<u>PLATTING BOARD AGENDA</u> MSB PUBLIC SAFETY BUILDING, STATION 6-2 (KGB) 4568 S. KNIK – GOOSE BAY ROAD, WASILLA (MILE 7 KNIK-GOOSE BAY RD)

November 2, 2023

STAFF REVIEW AND RECOMMENDATIONS PUBLIC HEARING NOVEMBER 2, 2023

PRELIMINARY PLAT: PANORAMIC PRESERVE

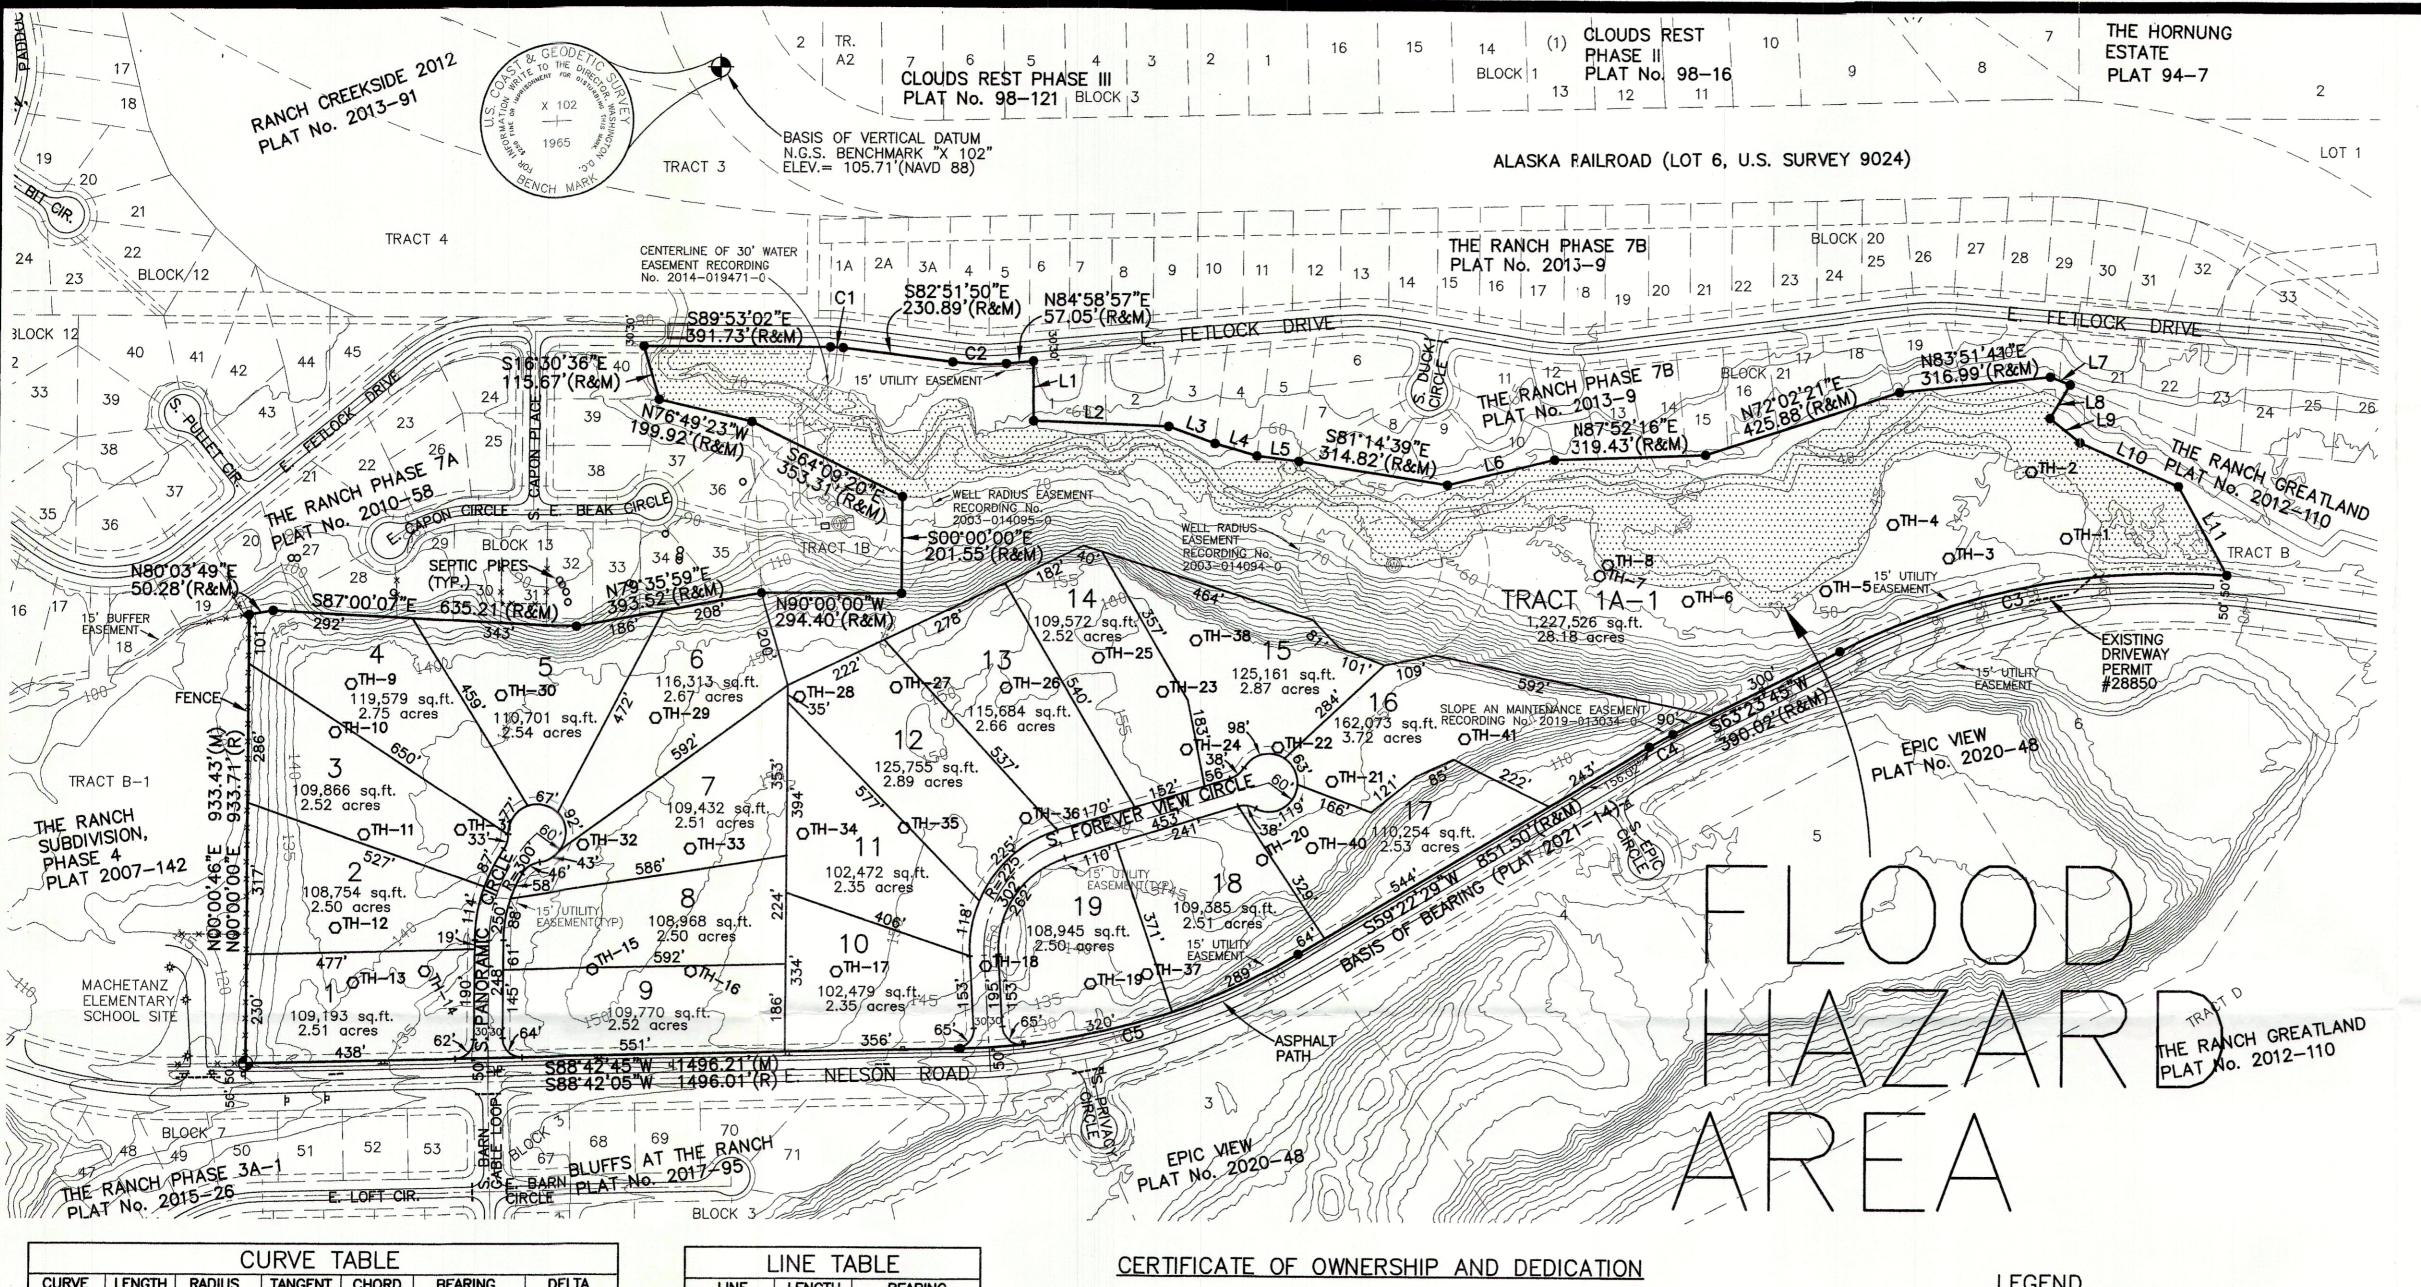
- 1. The current alignment of proposed S. Forever View Circle does not meet the minimum 650' intersection spacing requirement onto E. Nelson Road, pursuant to Subdivision Construction Manual A09.2(A)(4). The subdivision will need to be redesigned to meet this requirement.
- 2. Both proposed streets show a positive slope towards E. Nelson Road and will need to be redesigned with a negative slope away from E. Nelson Road, pursuant to SCM A09.4. This will require new plan and profile for the proposed streets. An updated drainage plan will also be required to address run-off from the proposed subdivision.
- 3. Topographic mapping does not reflect current contours.

New plats and new topographic mapping are required to be submitted, prior to Board hearing. Therefore, staff recommends a continuation to date uncertain, to allow the petitioner to resolve these issues.

Shadowridge Master Plan

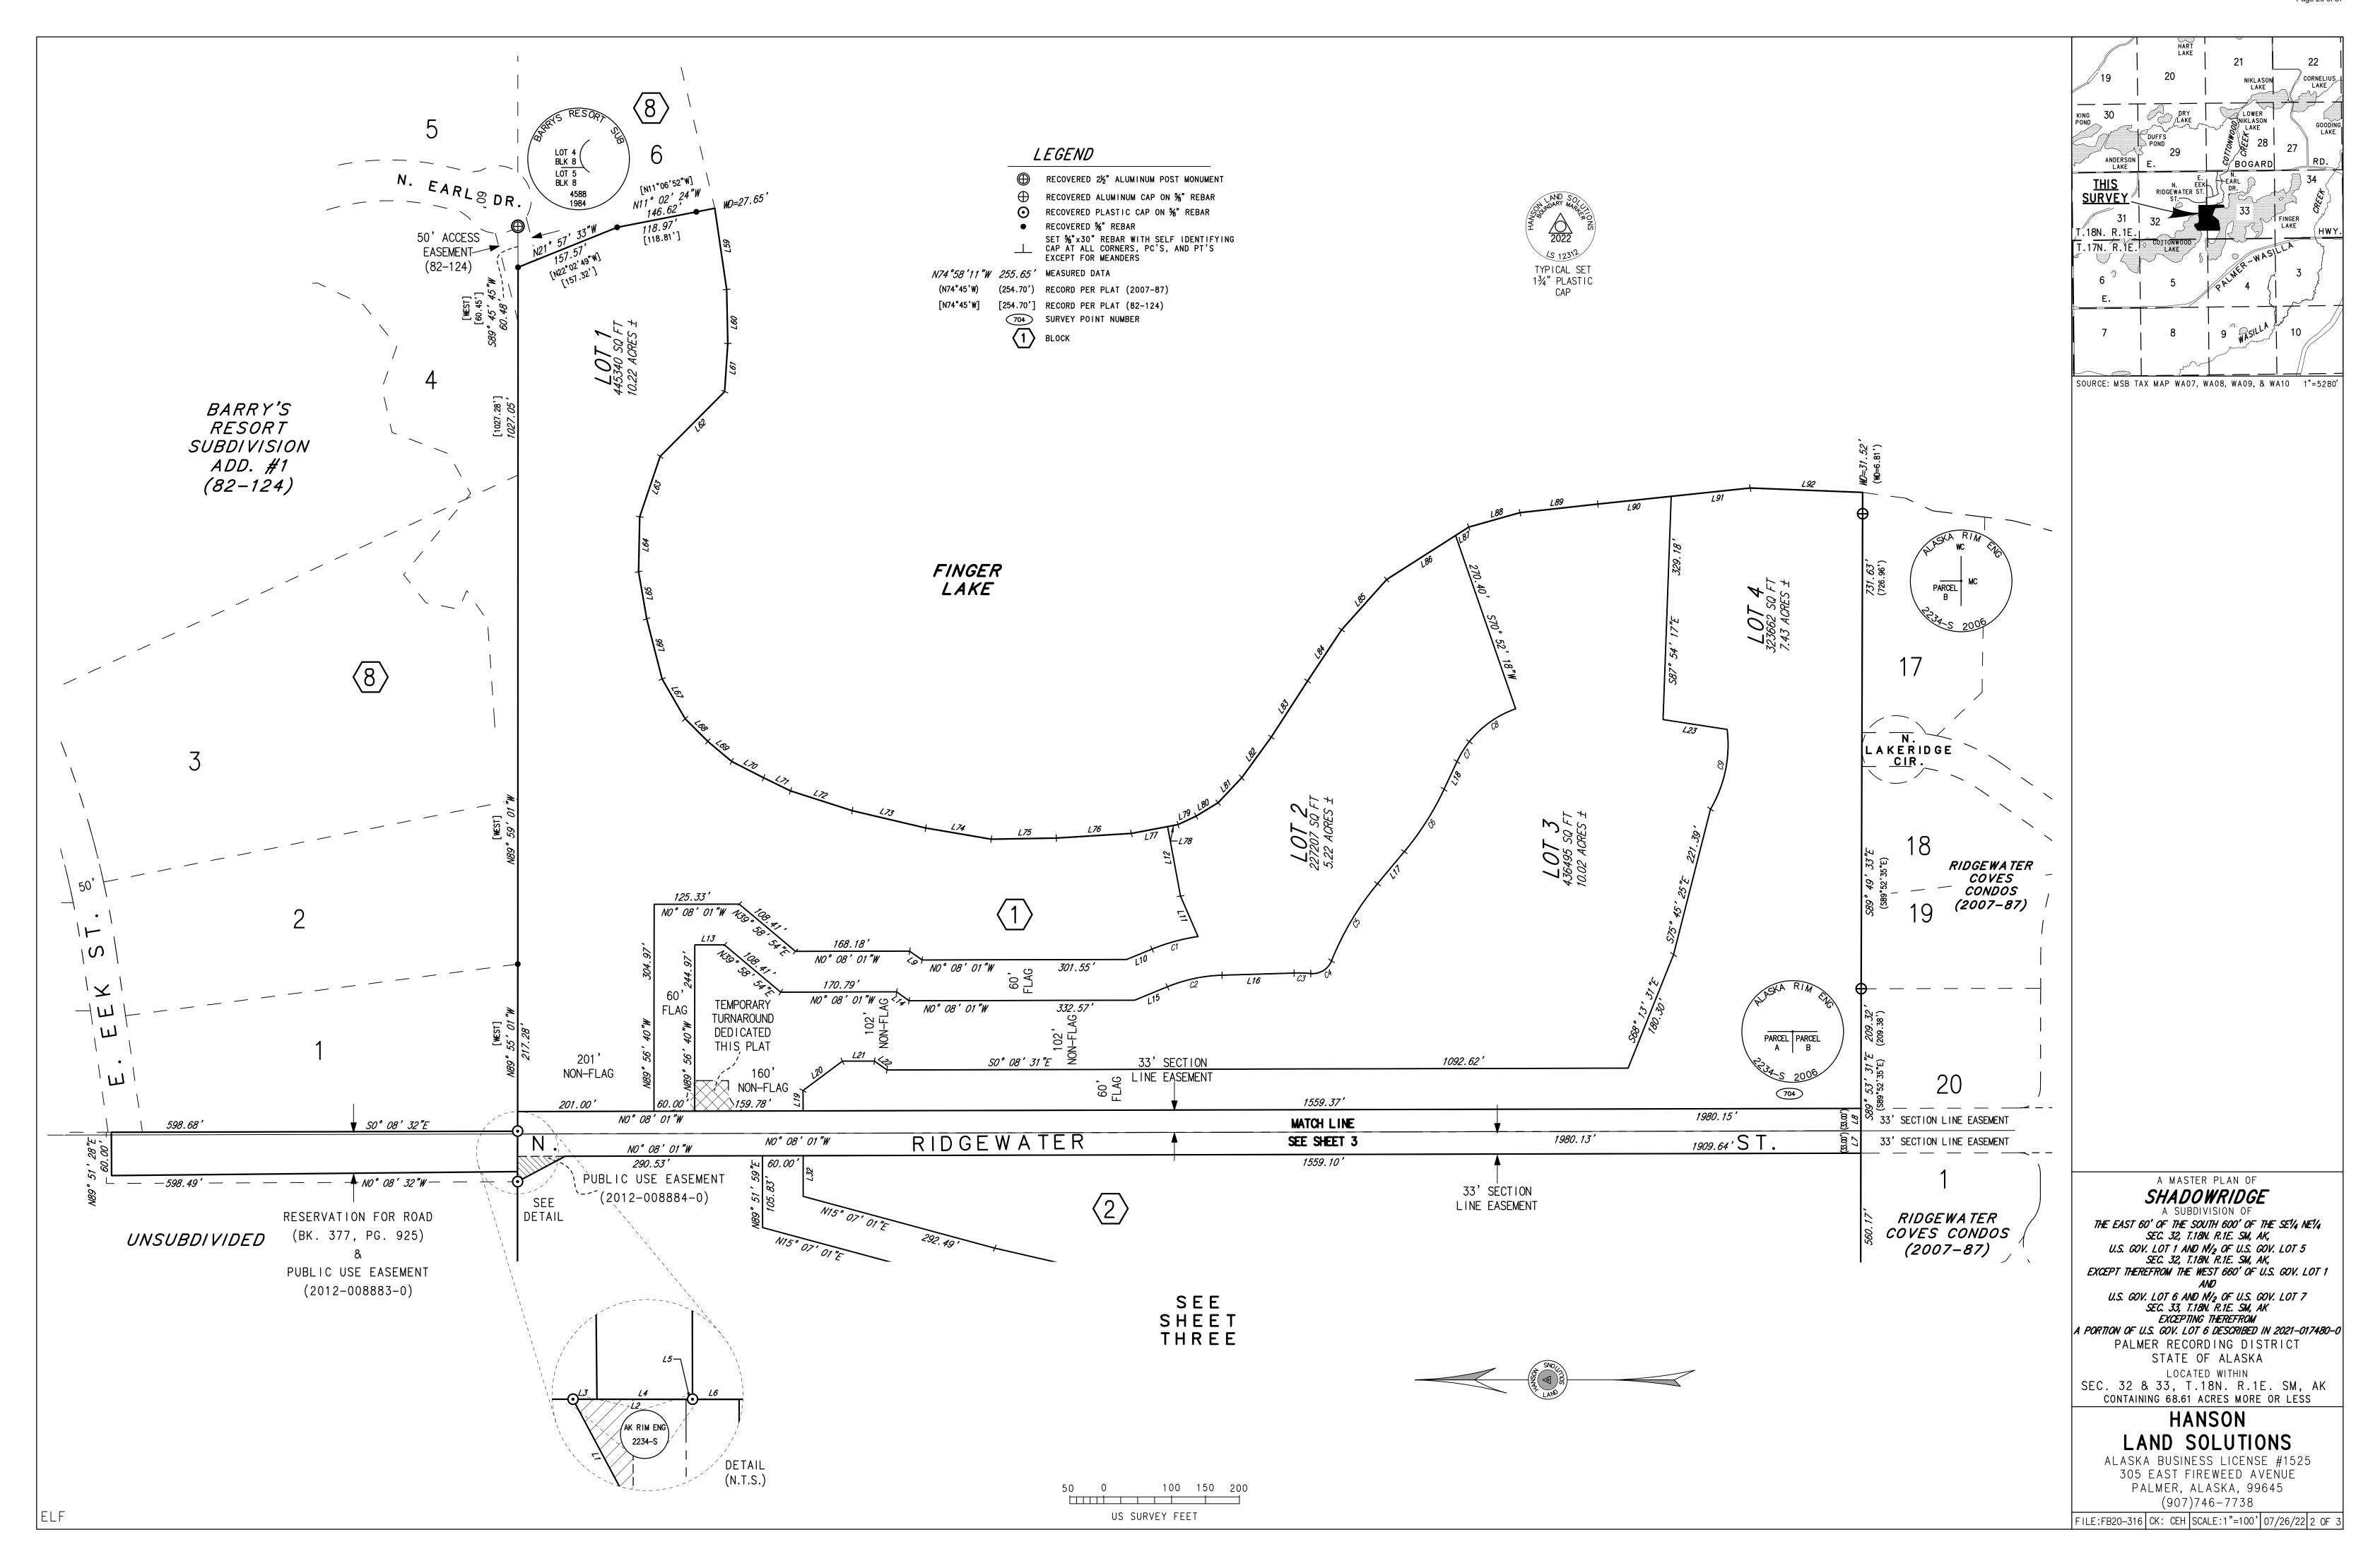
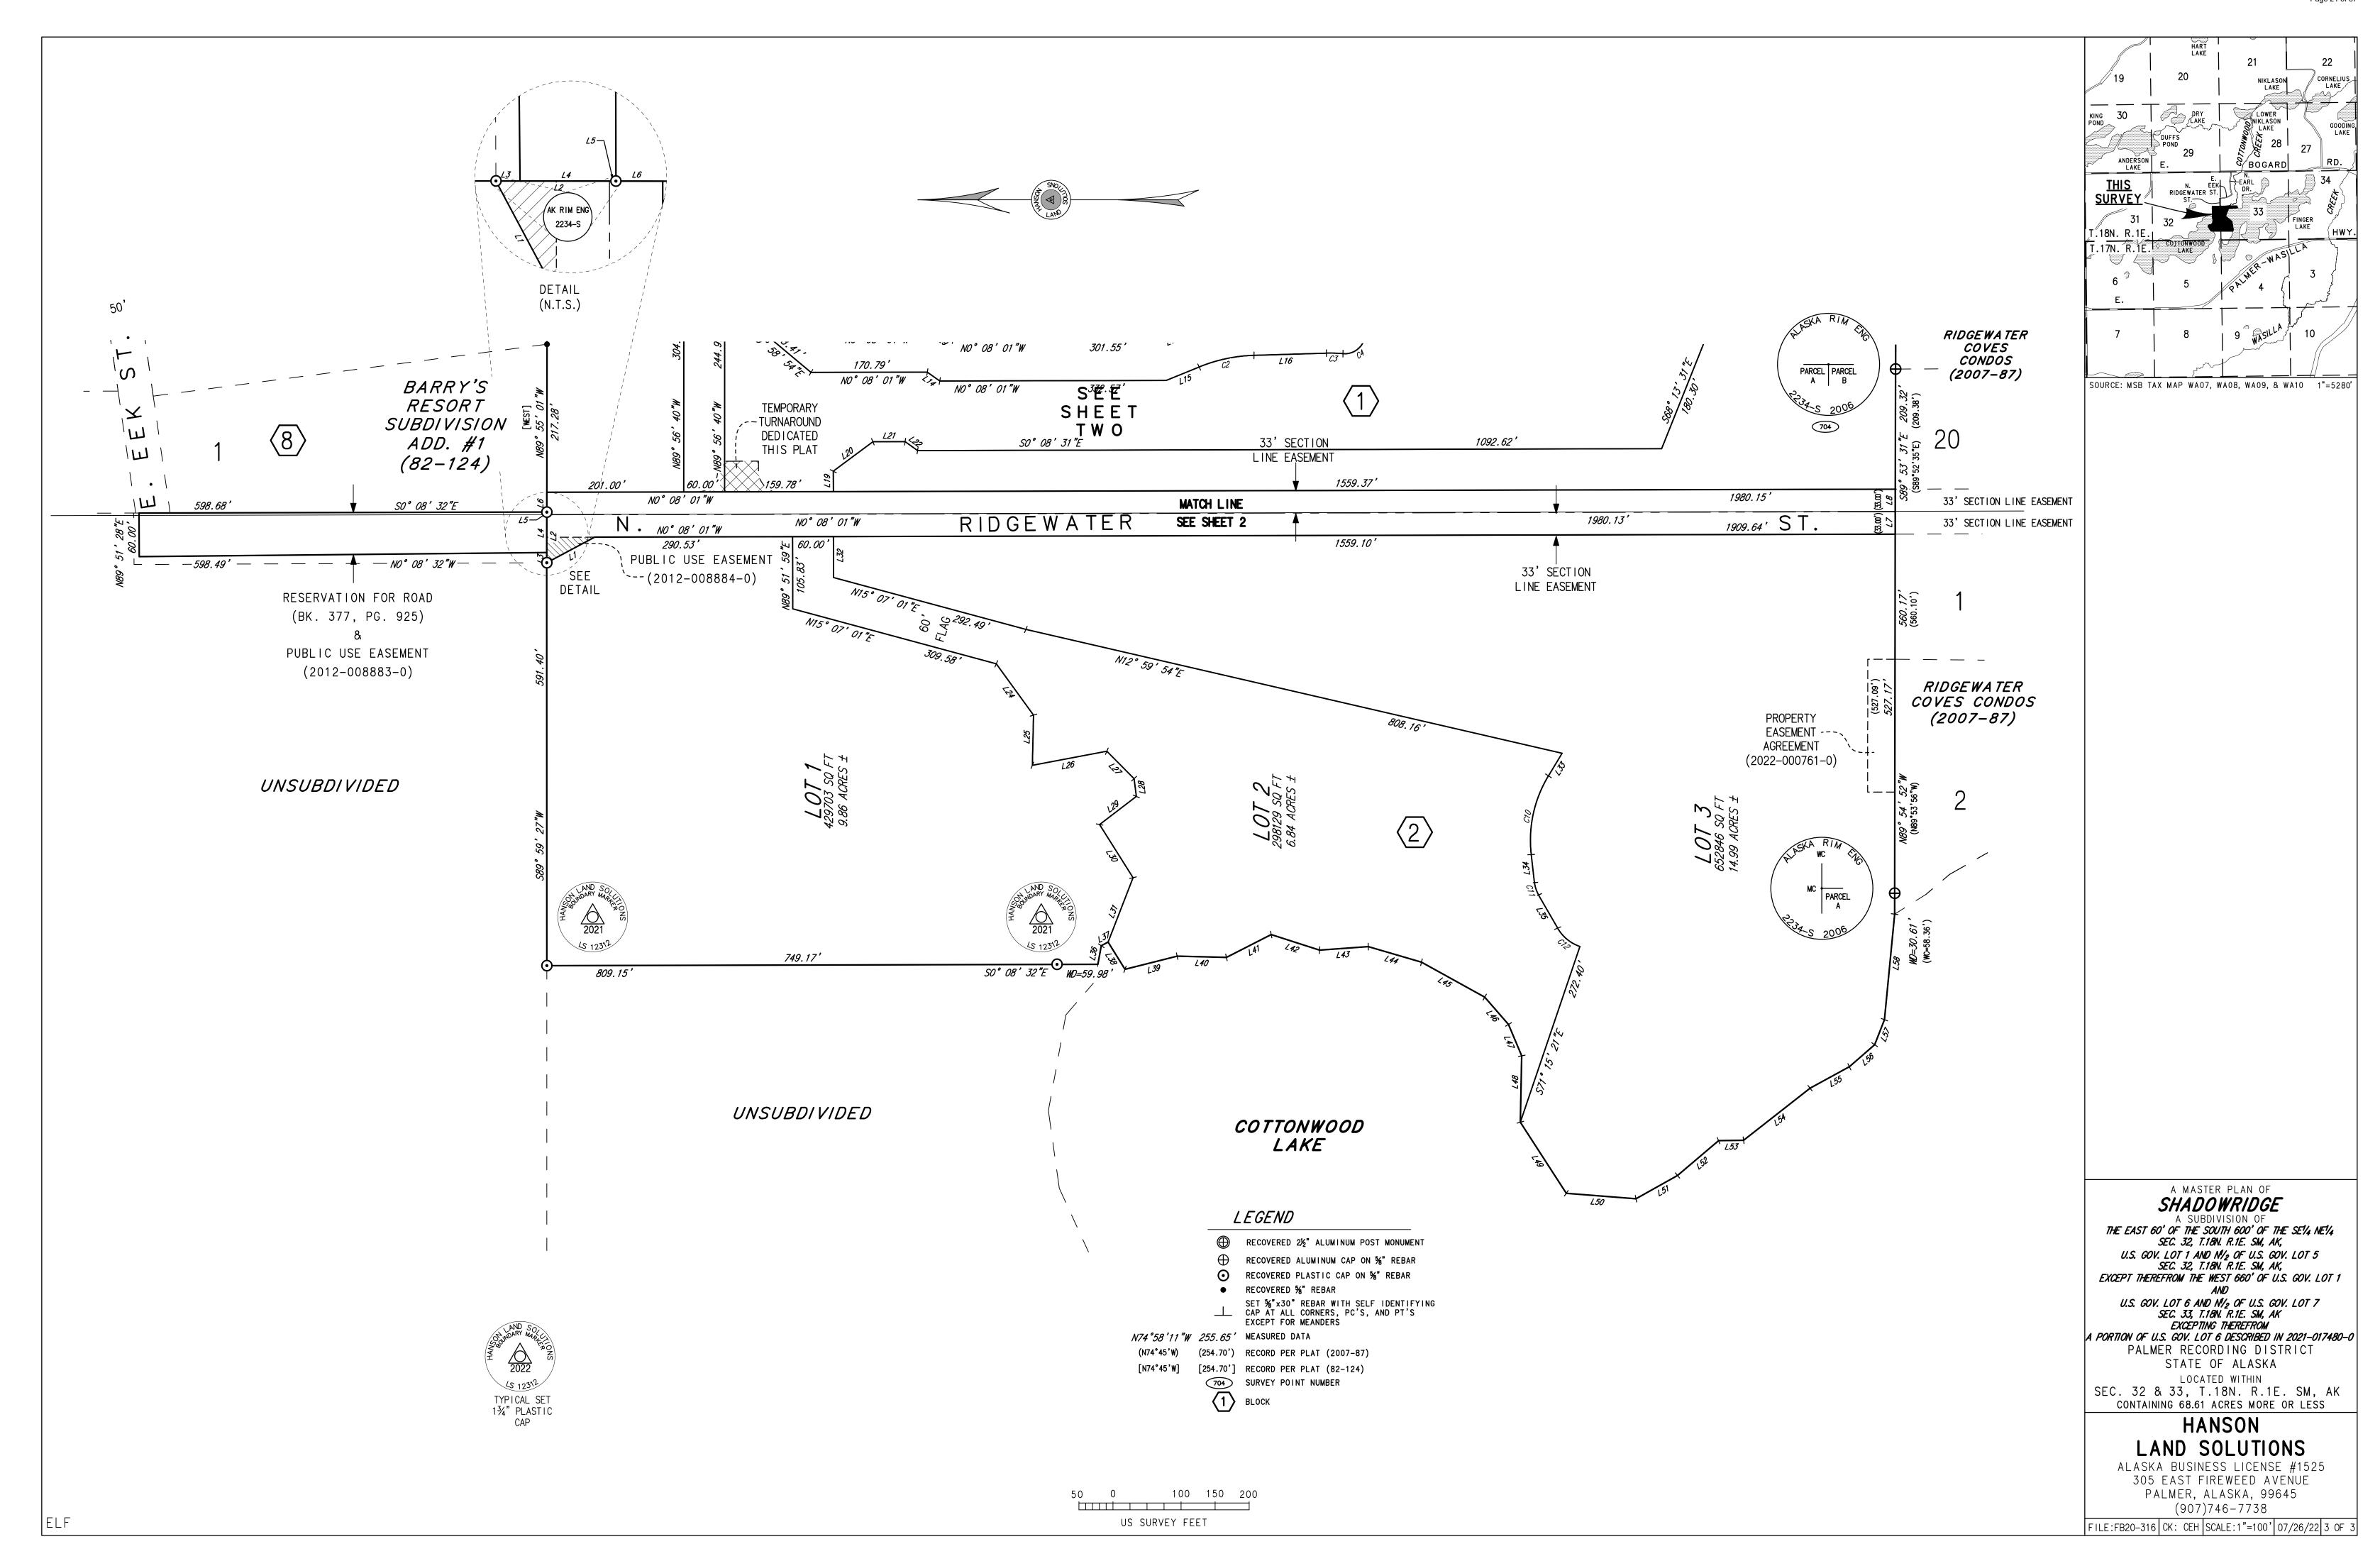
Multiple revisions of plan drawings have been submitted. It is unclear to PD&E, which plans are current. Submit up-to-date road and bridge construction plan and profile drawings as one combined set for PD&E review. The final plans should be included in the platting board packet.

Per MSB SCM F01.1(b) and D02.1 as a part of the preliminary plat submittal, a drainage plan for the entire site is required. Applicant and only provided a drainage plan for regrading areas. Please resubmit drainage plan showing entire subdivision.
